# R. E. GINNA NUCLEAR POWER PLANT MANAGEMENT ORGANIZATION CHART

## Attachment B

The proposed Technical Specification change reflects changes in the RG&E management organization and changes in the Ginna organization. Following the sudden death of the Senior Vice President, Operations, RG&E Management, with the concurrence of the Board of Directors, has decided not to fill this position. Under the new organization the vice presidents who had reported to the Senior Vice President, Operations, will now report directly to the President and Chief Operating Officer. The President of the Company has had an extensive involvement with the Ginna plant in various capacities since the time of construction.

FIGURE 6.2-1

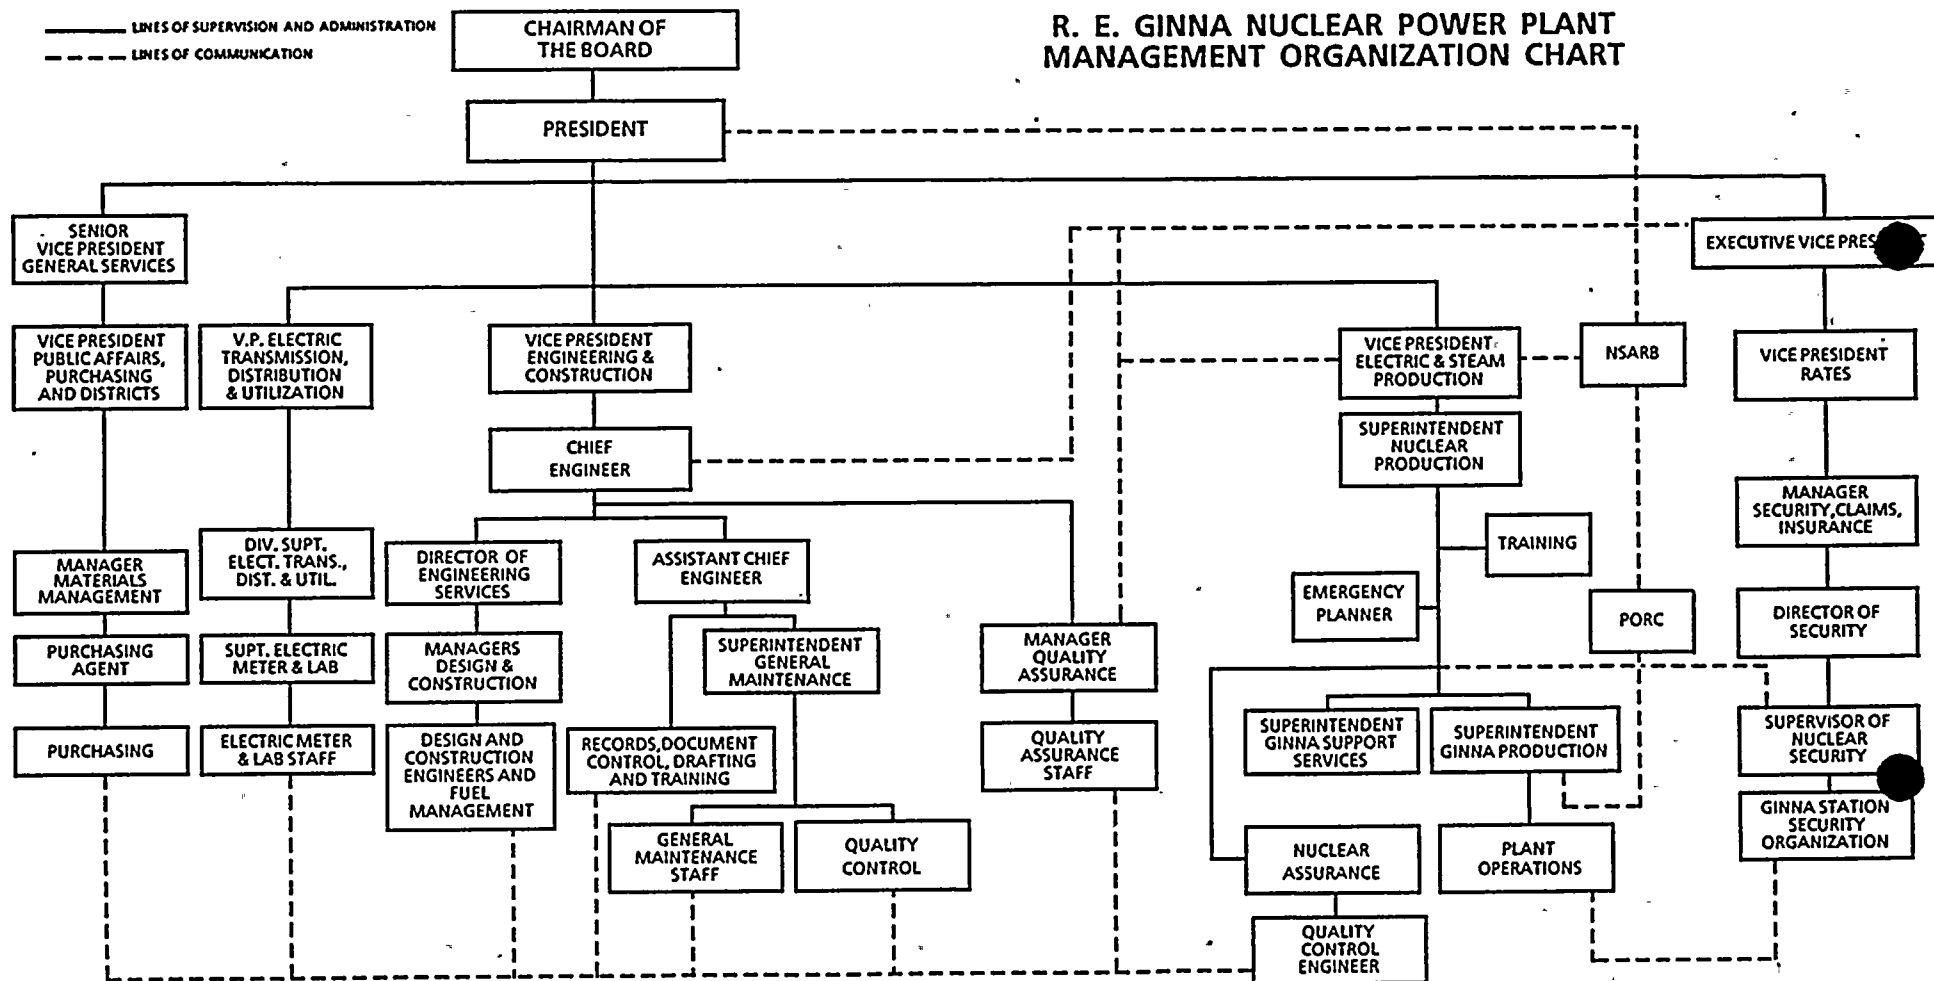
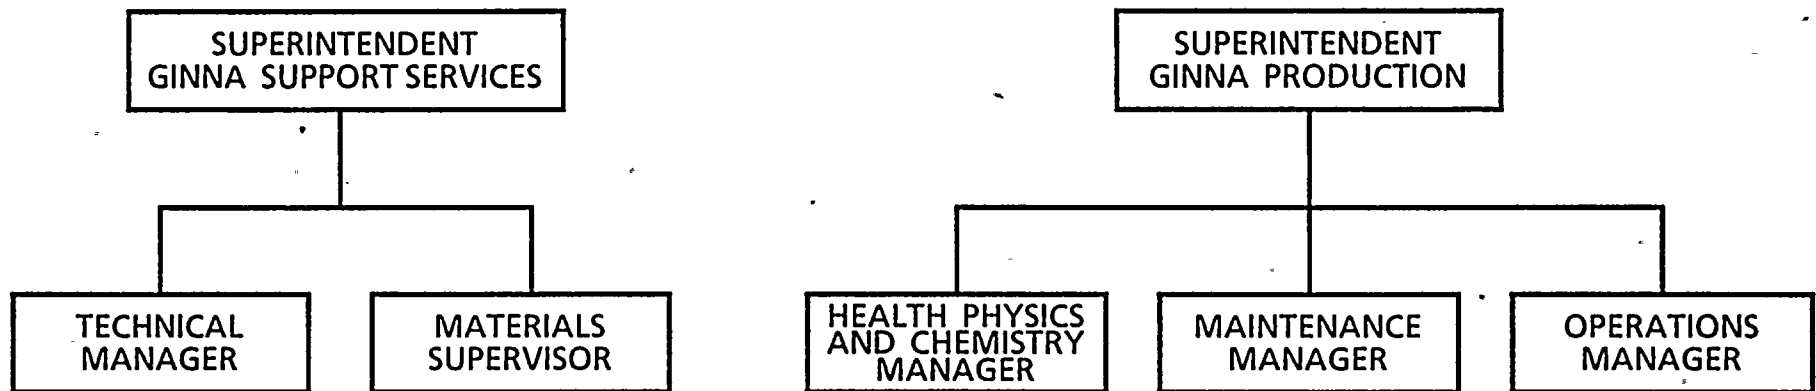
A realignment of responsibilities in the Engineering organization has resulted in a change in title whereby the Engineering Department now reports to the Vice President, Engineering and Construction, and a position of Chief Engineer has been reinstated. The position of Assistant Chief Engineer, Engineering and Construction, has been replaced by the position of Director of Engineering Services. In order to maintain independence of the Quality Assurance organization from the design, construction and other engineering functions, the Executive Vice President will have overall responsibility and authority to direct Quality Assurance, however, the day-to-day direction will come from the Chief Engineer.

The Ginna organization changes consist of the following:

The position of Superintendent, Nuclear Production and Superintendent of Ginna Station has been changed to the position of Superintendent, Nuclear Production.

The position of Superintendent of Ginna Station has been divided into Superintendent-Ginna Production and Superintendent-Ginna Support Services. The Superintendent Ginna-Production is responsible for overall on-site Ginna Station operation.

The position of Assistant Superintendent has been eliminated.

Nuclear Assurance will report to the Superintendent, Nuclear Production.

Central Records will report to the Nuclear Assurance Manager.

The Health Physics and Chemistry Manager, the Maintenance Manager, and the Operation Manager will report to the Superintendent-Ginna Production.

The Technical Manager and the Materials Supervisor will report to the Superintendent-Ginna Support Services.

Figure 6.2-3

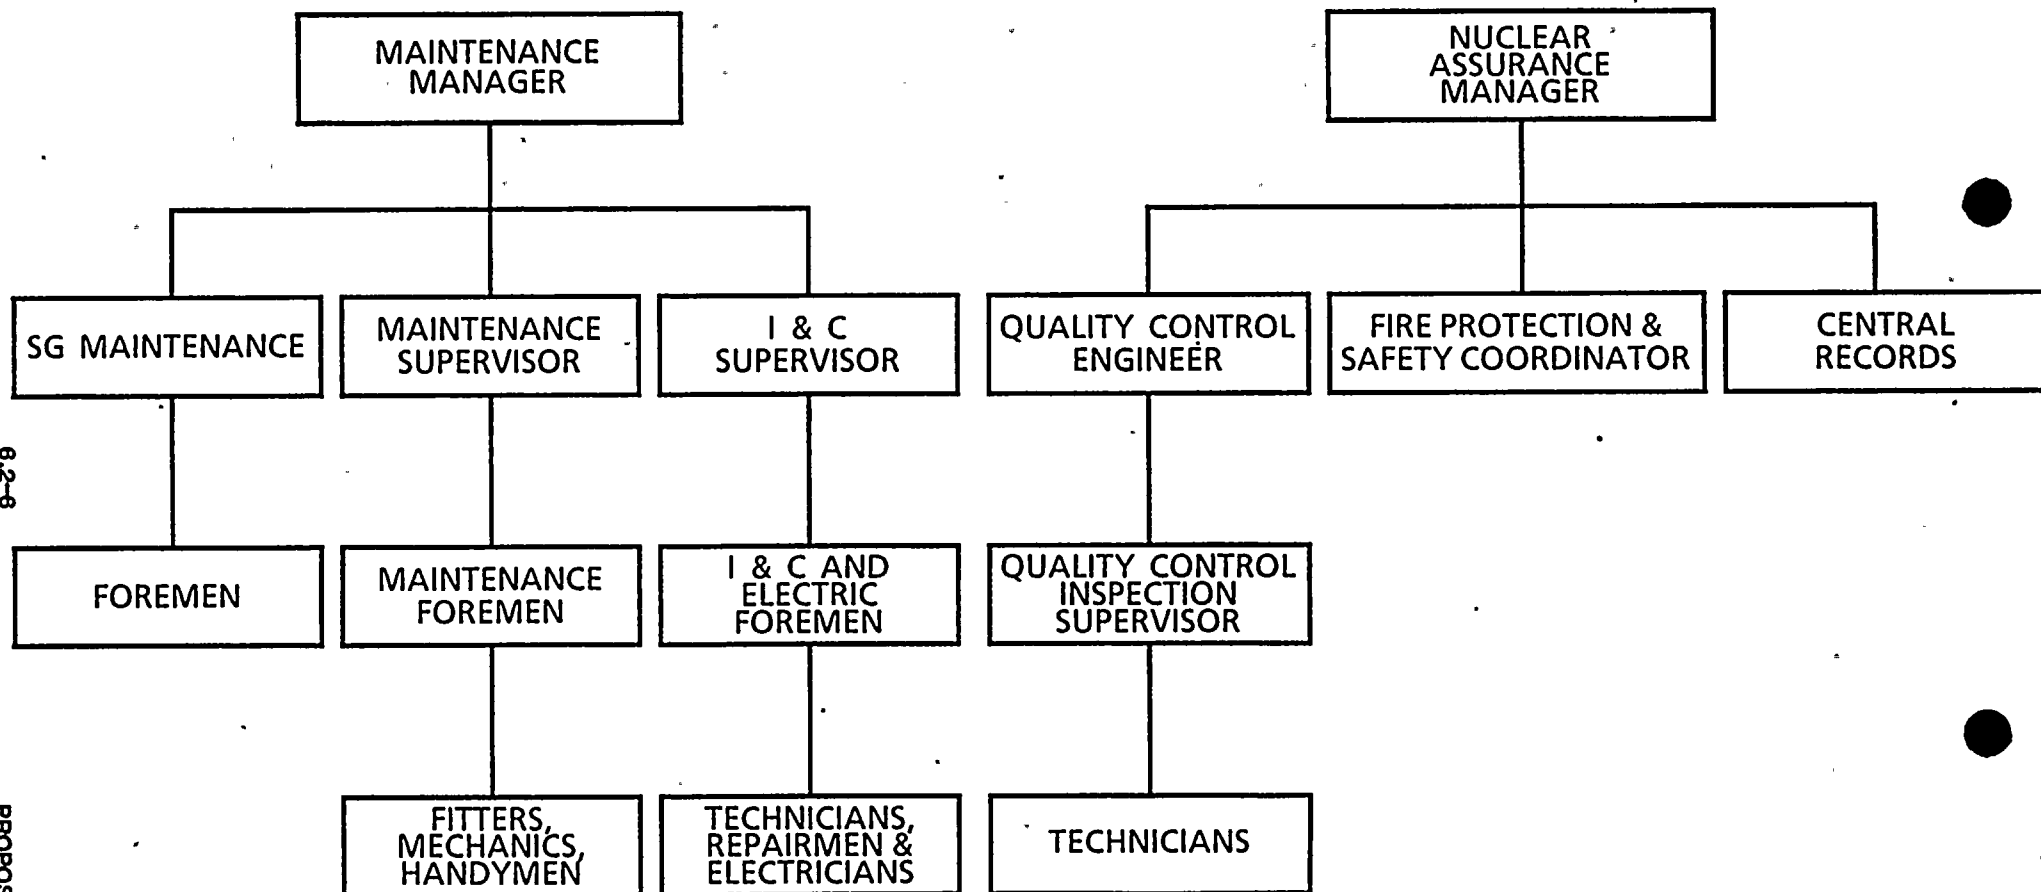
The removal of the communication path from the Quality Control Engineer to the Superintendent, Nuclear Production and Superintendent of Ginna Station will not effect quality control. The Engineer will still have the same controls, however, he will communicate through the Nuclear Assurance Manager.

Figure 6.2-4

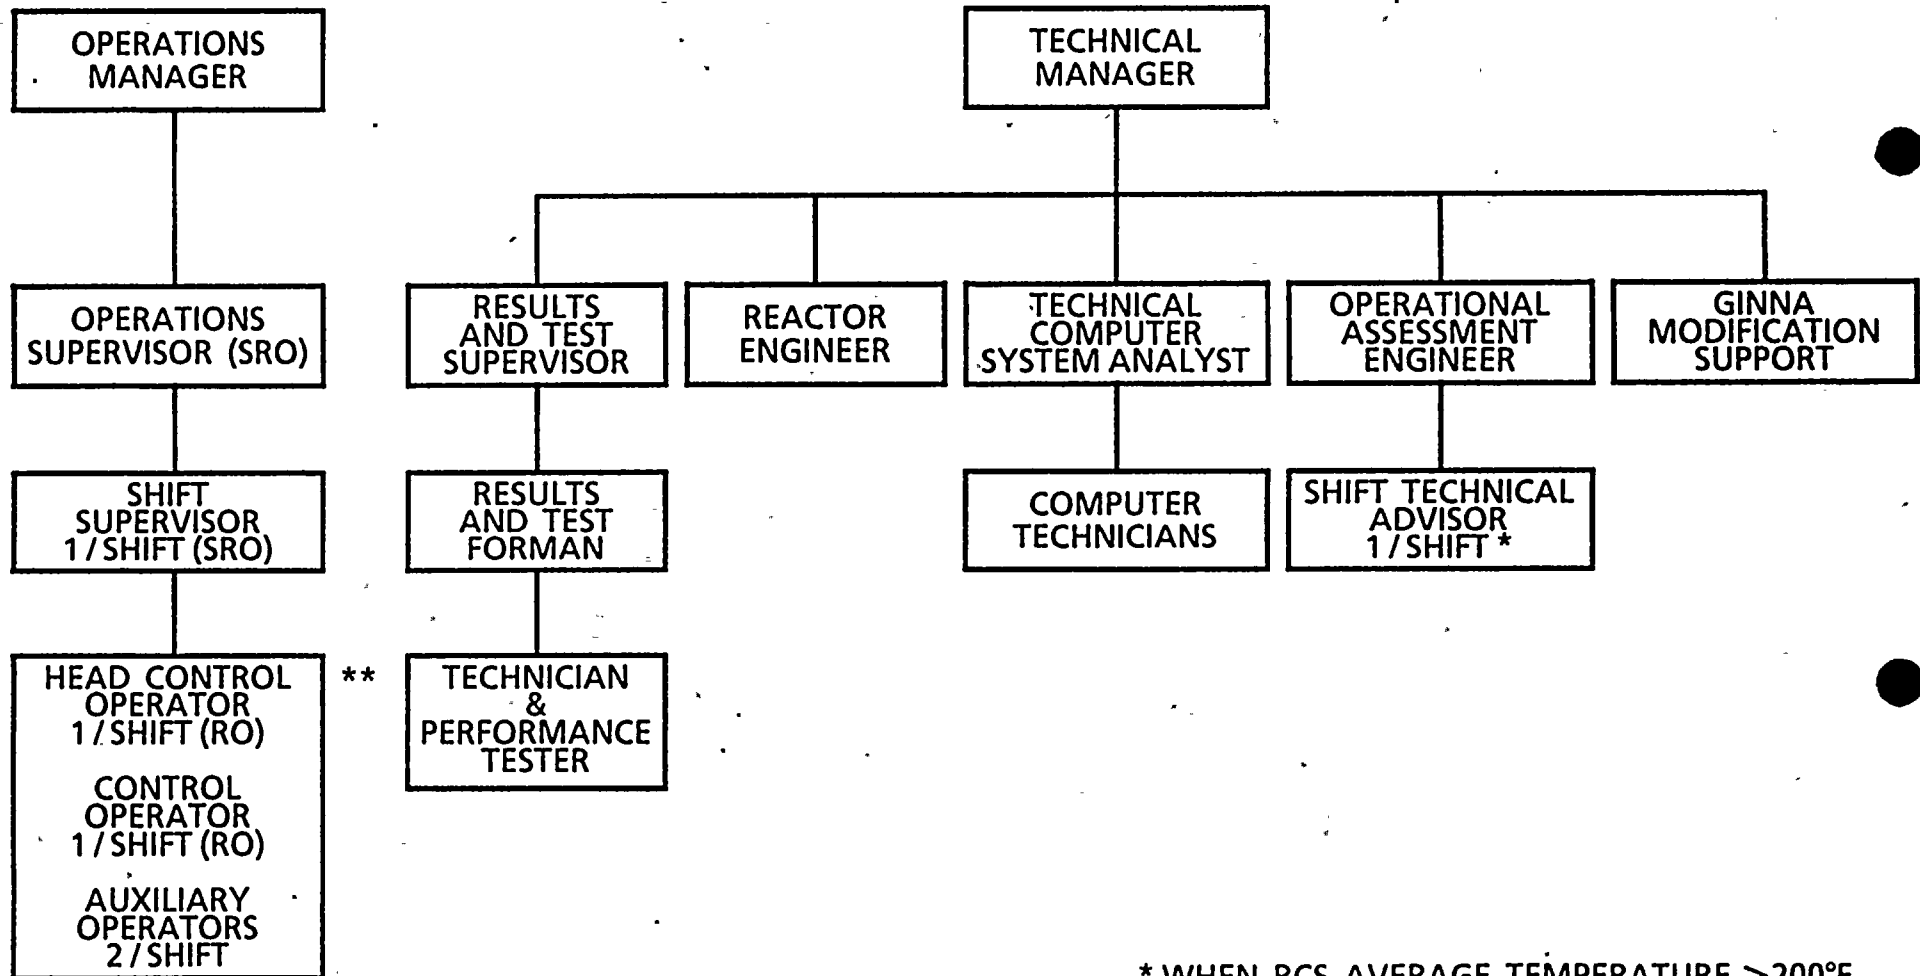
Minor changes have also been made under the various managers which is reflected in the figures.
